# CITY OF ALBUQUERQUE

**RE: Lot 16 Block 2 Unit SAD 228  
6504 Camino Del Oeste NW  
Grading and Drainage Plan  
Engineers Stamp Date 1/23/2020 (D10D003G16)  
Pad Certification Date 6/28/2020**

## DRAINAGE AND TRANSPORTATION INFORMATION SHEET (REV 6/2018)

ENGINEER'S SEAL  1/23/20 DAVID SOULE P.E. #14522	6504 CAMINO DEL OESTE	DRAWN BY: WCVJ
	GRADING AND DRAINAGE PLAN	DATE: 11-25-19
 1606 CENTRAL AVENUE SE SUITE 201 ALBUQUERQUE, NM 87106 (505) 872-5999		2109091-LAYOUT-11-25-19
		SHEET #
		JOB # 2109091

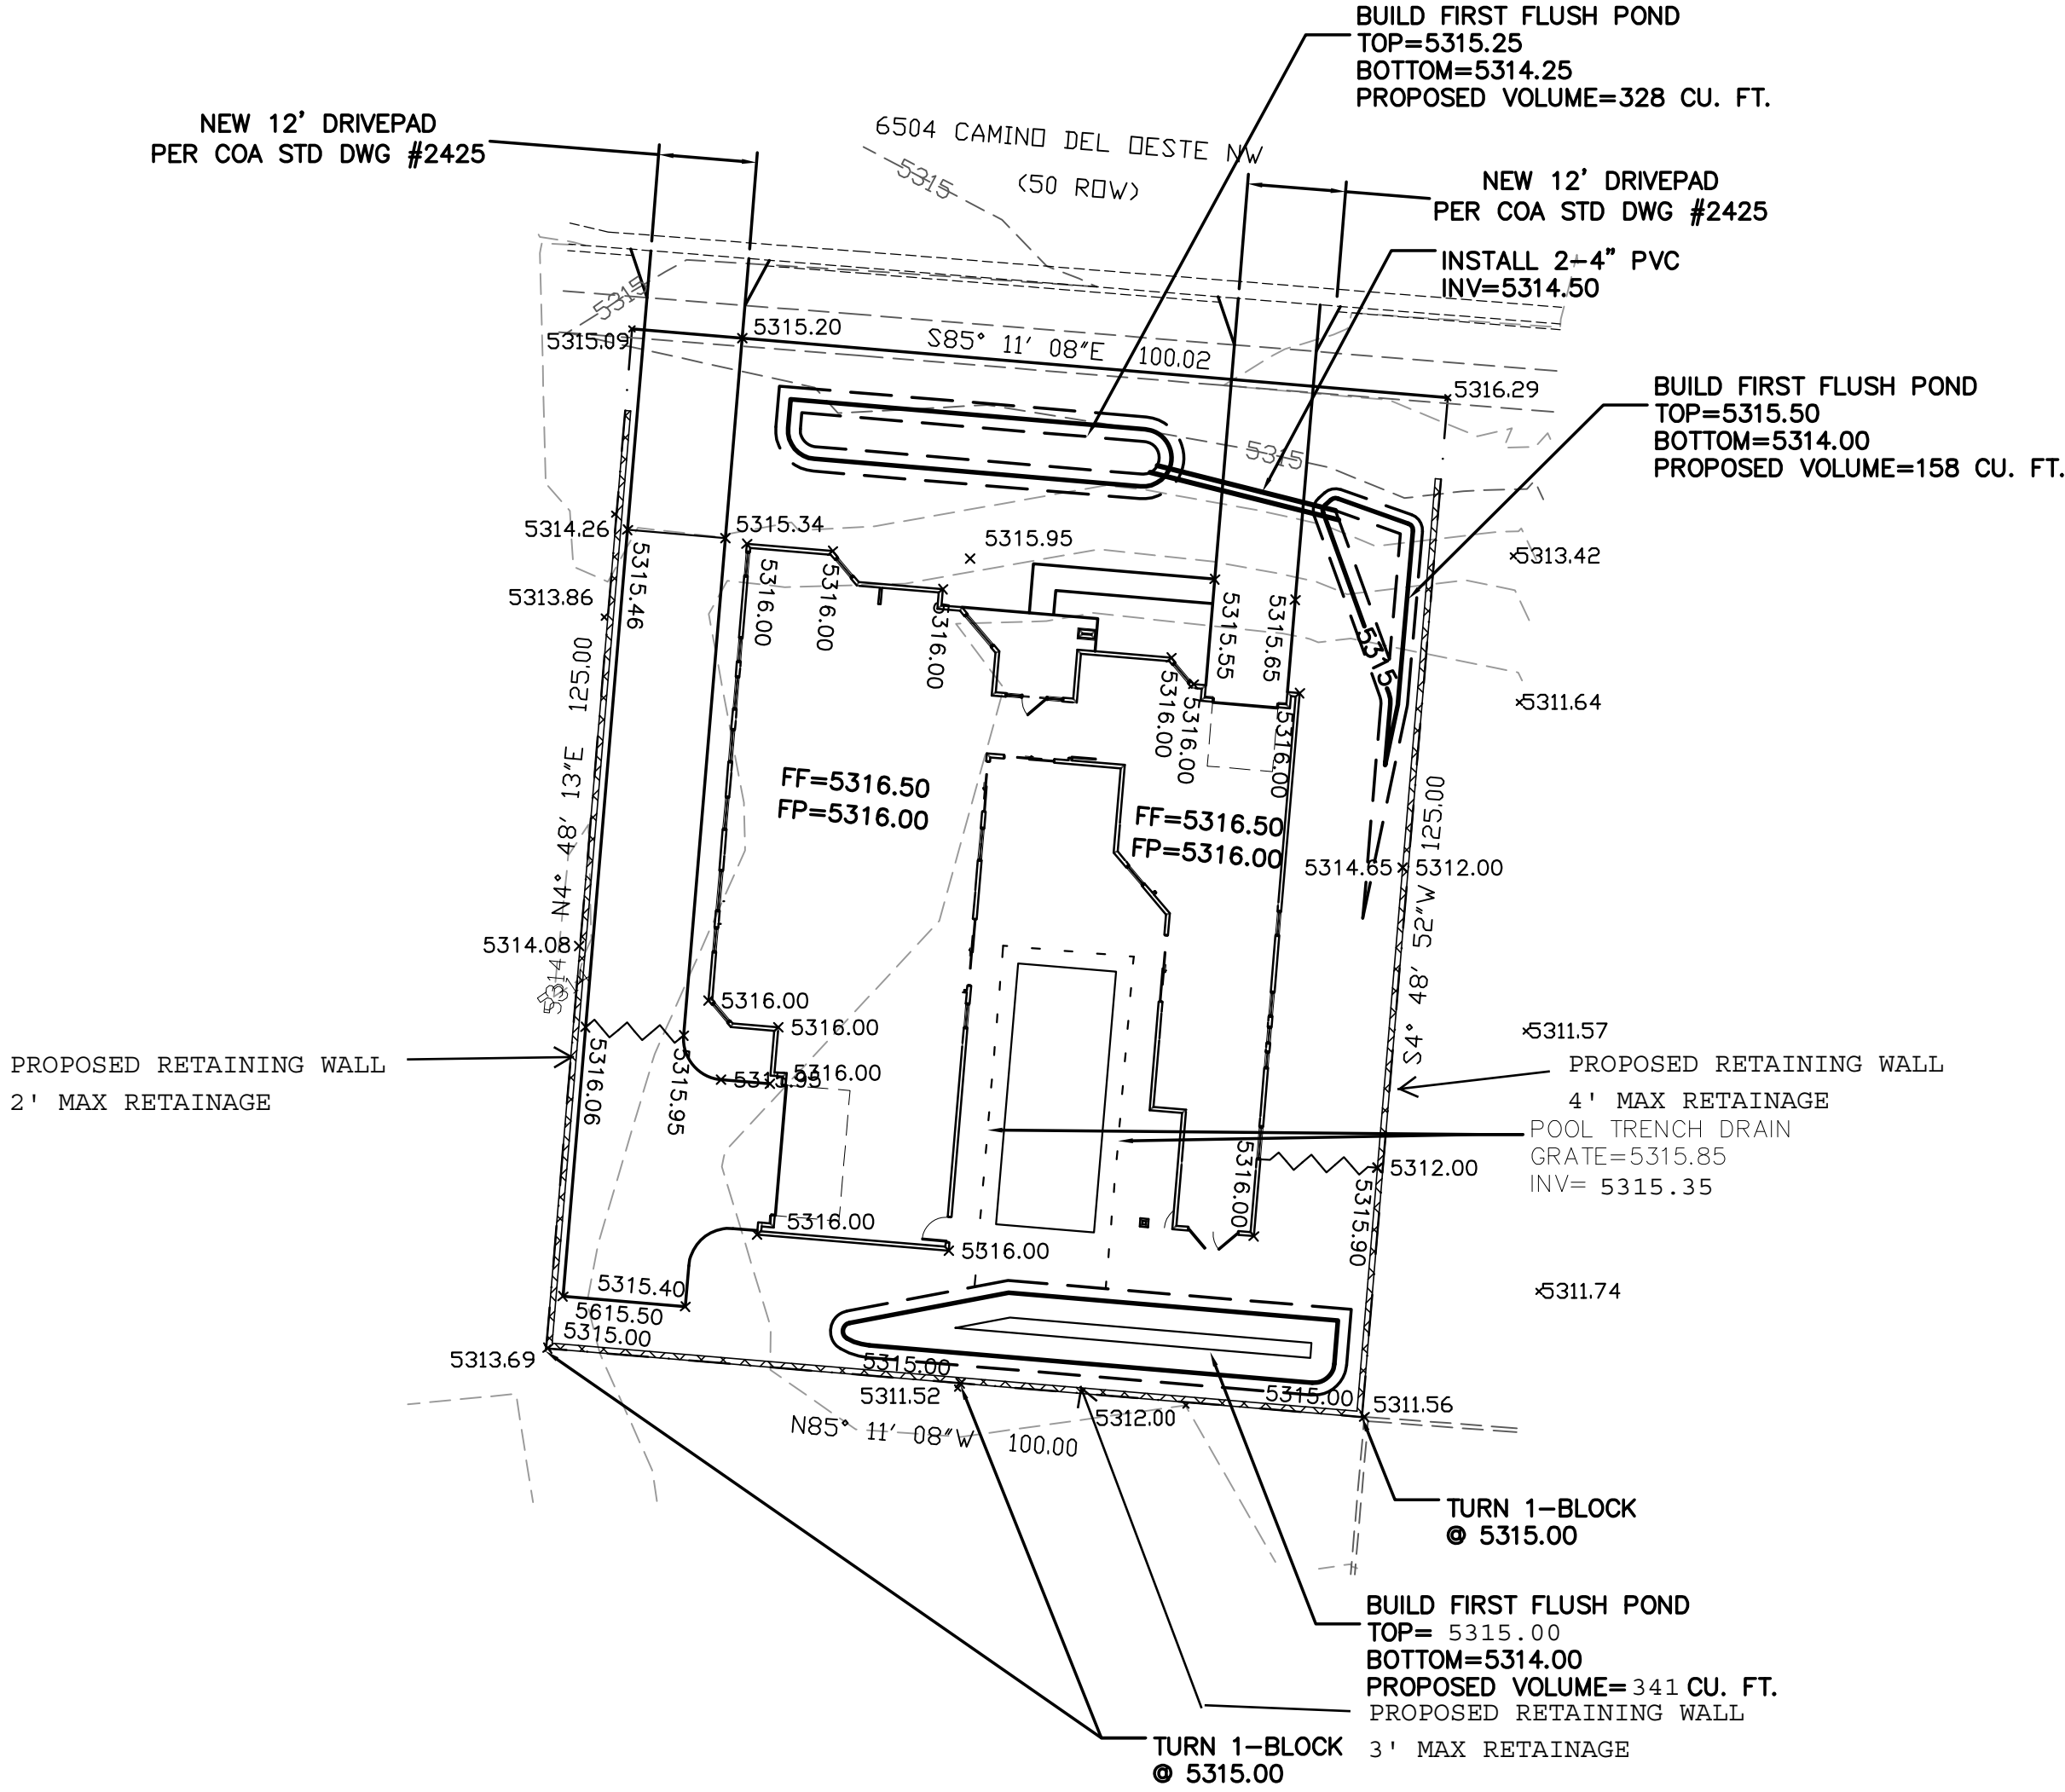
Based upon the information provided in your submittal received 4/6/2020, this plan is approved for Building Permit.

Reiterate to the Owner/Contractor that a separate permit for a garden/retaining wall must be obtained, with the approved G&D plan.

Prior to Certificate of Occupancy release, Engineer Certification per the DPM checklist of this plan will be required.
